READING BOROUGH COUNCIL

PROOF OF EVIDENCE ON DAYLIGHT AND SUNLIGHT

Appeal Site: Vastern Court, Reading

Planning Inspectorate Reference: APP/E0345/W/21/3289748

Figure 4. 17-29 Vastern Road, annotated to show ranges of percentage loss in VSC and daylight area. Photo taken in 2019.

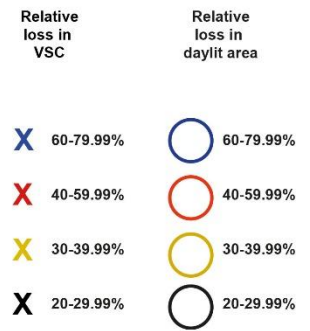
- 4.9 Compared to the existing baseline, loss of VSC to all 57 windows analysed at 17-49 Vastern Road would be outside the BRE guidelines. 39 of these windows would have relative reductions of 33.0-39.8% (described as 'moderate reduction' in table 10.14 of the Environmental Statement) and 18 windows would have relative reductions of 40% or more (described as 'major' in table 10.14).

- 4.10 Effects on daylight distribution, compared to the existing baseline, would be outside the BRE guidelines for 36 rooms of the 50 analysed in 17-49 Vastern Road. 11 of these would have impacts more than double the BRE recommendation.

- 4.11 Relative losses of daylit area for these rooms would range from 23%-79%. Figures 4 and 5 show where these windows and rooms are.

4.12 A particular concern is loss of light to the ground floor rooms which would normally be expected to be main living rooms. Thirteen of these rooms would have VSC reductions more than double the BRE guidelines, and eleven of them would have impacts on their daylight area outside the BRE guidelines. These rooms would appear substantially darker, and more of the room would appear gloomy.

- 4.13 It should be noted that many rooms in 17-49 Vastern Road have a three pane bay window. This includes all the ground floor living rooms in 17-49 Vastern Road and also first floor rooms in 31-49 Vastern Road. In these cases the Environmental Statement has only analysed loss of light to the central window. This is acceptable as it is in line with the guidance in paragraph 2.2.6 of 'Site layout planning for daylight and sunlight: a guide to good practice', which gives recommendations in terms of loss of light to the main window. However it means that the total number of windows actually affected is much more than 57. In total, up to 110 windows in 17-49 Vastern Road could have losses of VSC outside the BRE guidelines.

Figure 6. 51 Vastern Road, annotated to show ranges of percentage loss in VSC. Photo from Google Streetview.

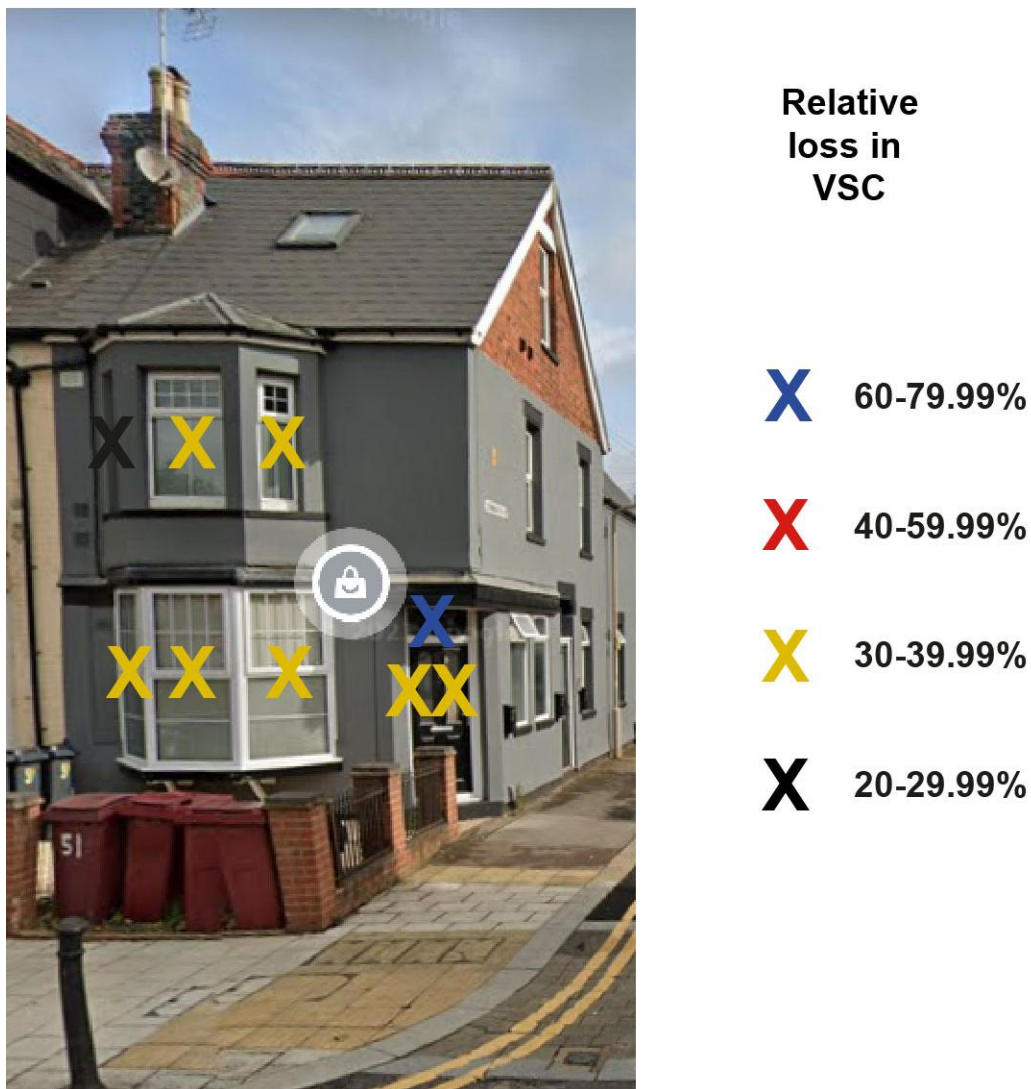
- 4.14 Losses of VSC to nine windows at 51 Vastern Road (including some secondary windows lighting a doorway, and in, this case, side bay windows) would be outside the BRE guidelines. Eight of these windows would have relative reductions of 26.7-36.5% and one window would have a relative reduction of 73.9%, though this is a secondary window lighting the doorway and it has an overhang above it. Figure 6 shows where these windows are. Impacts on daylight distribution in number 51 would be within the guidelines.

Figure 7. Drawing by CHP Surveyors indicating vertical sky components on the facades of the Hermes (Reading Metropolitan/80 Caversham Road) development with the Appeal Scheme in place.

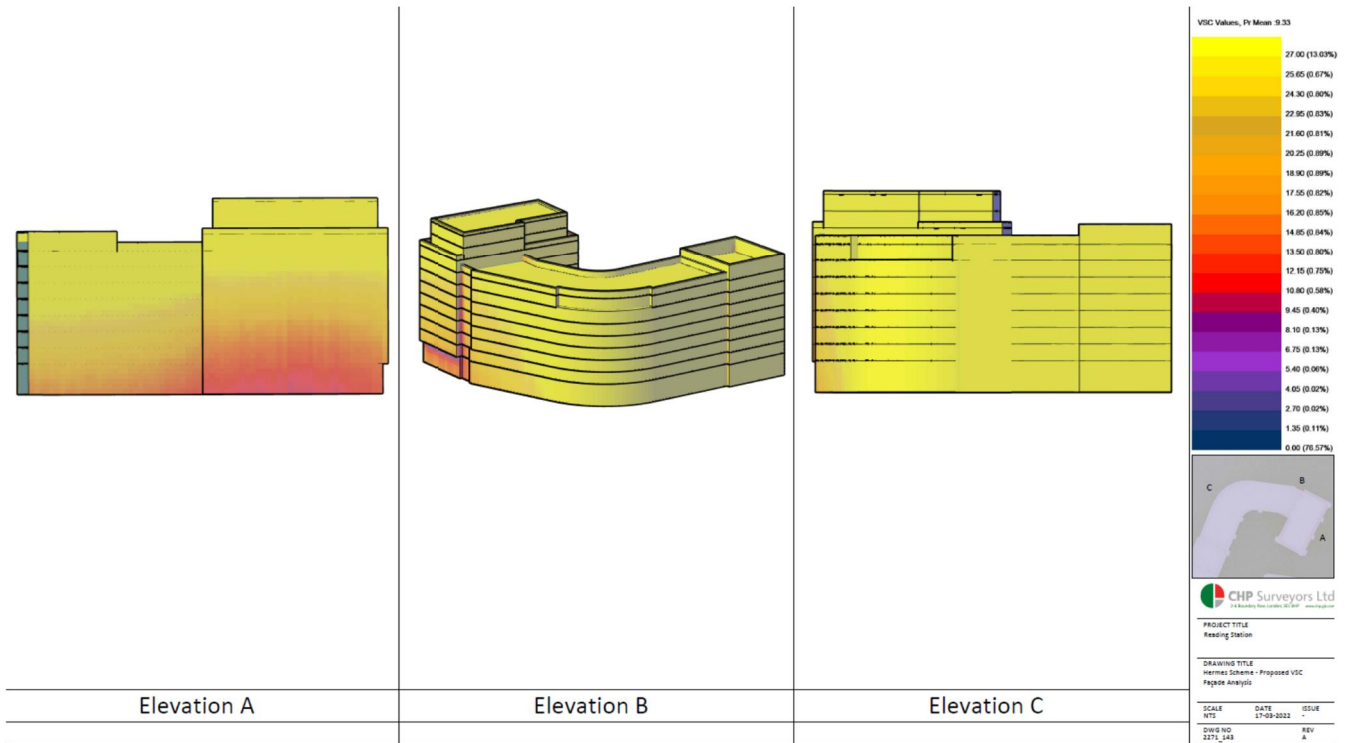
- 5.5 In principle a vertical sky component analysis on a regular grid of points can be used to assess daylight provision to a façade in cases where detailed window design has not yet been carried out. The Hermes scheme, as an outline planning application, could be said to fall into this category. The SSE scheme does not; it is the subject of a detailed planning application, with elevations and floor plans of the affected areas. A detailed study of loss of light to this scheme should have been carried out for the actual window and room layouts.

- 5.6 In addition the shading on the drawings is not clear and it is not possible to judge accurately what the vertical sky component might be at any particular point. This is a particular issue for the Hermes drawings where the critical façade facing the proposed Appeal scheme is only shown obliquely (it forms the left hand portion of the middle drawing in Figure 7). The Hermes drawings do not give vertical sky components for Block C of the Hermes development; Block C is the block likely to be most affected by the proposed Appeal Scheme, and incorporates shared ownership dwellings in the indicative scheme for the Hermes site.

- 5.7 Overall, it can be concluded that the proposed Appeal Scheme will have some impact on the Hermes and SSE developments, because the colours are different. But it is not possible to tell how large that impact will be, or whether future residents of those sites would have adequate daylight with the Appeal Scheme in place.

Figure 10. Plan by James Crowley of CHP Surveyors showing areas (in yellow) within Blocks B and C of the illustrative scheme which can receive two hour's sun on March 21, without the proposed 80 Caversham Road scheme. North is at the top of the plan.

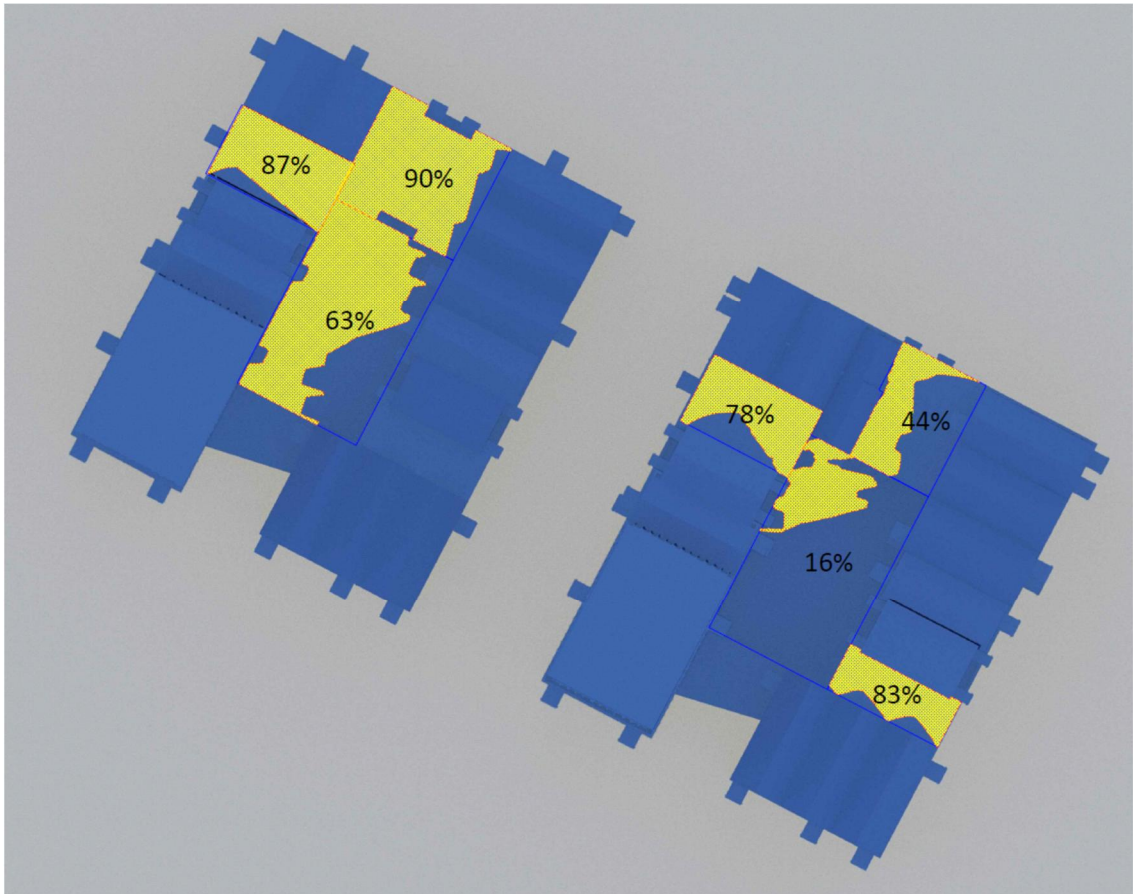
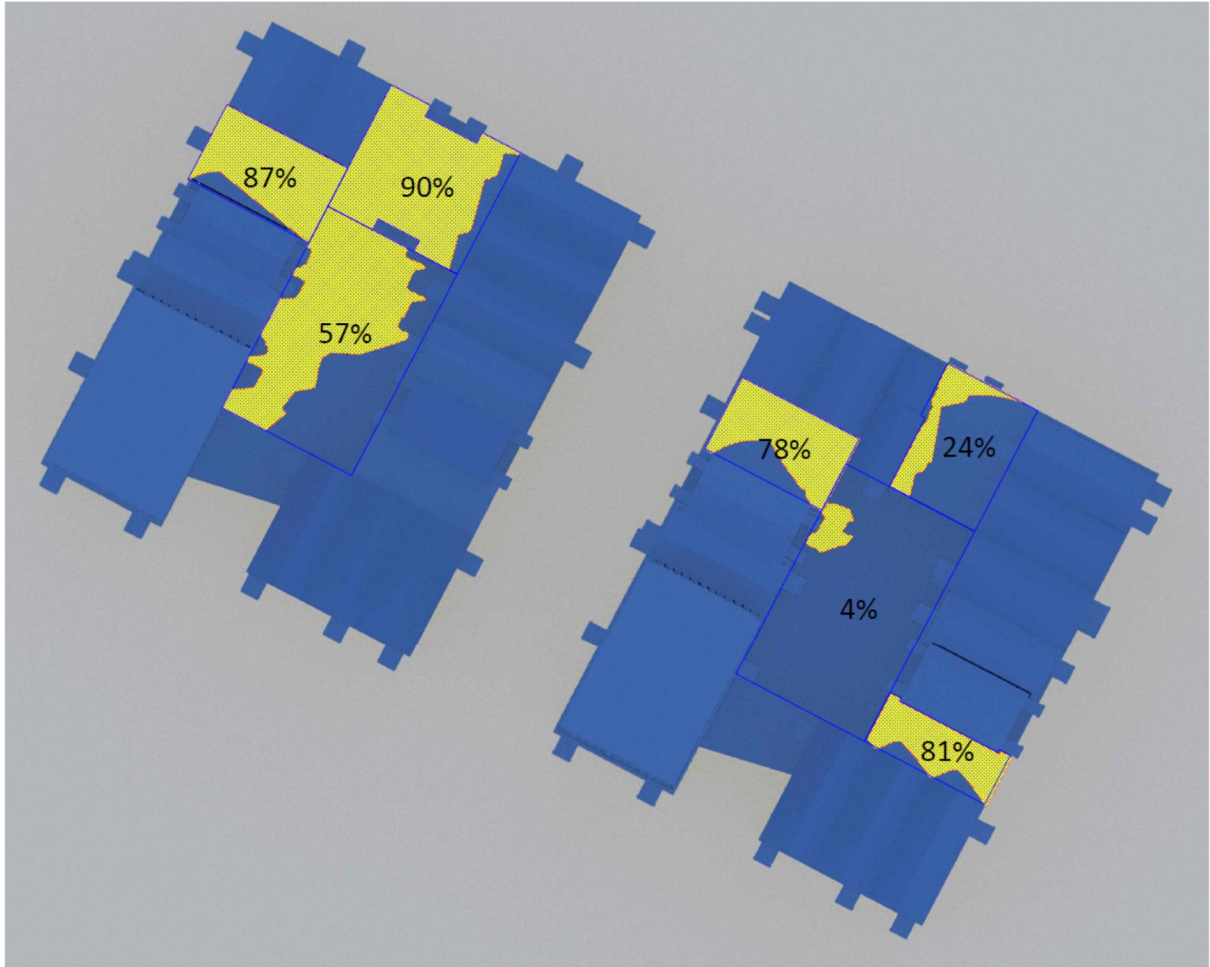
- 7.4 James Crowley has also assessed sunlight provision to courtyards and potential roof terraces in Blocks B and C of the proposed illustrative scheme. The results are given in Figures 10 and 11.

- 7.5 The results show that most of the roof terraces and the courtyard to Block B would meet the BRE guidelines. The courtyard and one of the roof terraces to Block C would not, and would be viewed as inadequately sunlit. The difference in predicted sunlight provision between the two courtyards is surprising given that the two blocks are of similar design; James Crowley has indicated that this is because of the shadowing caused by the tall Block D, next to Block C.
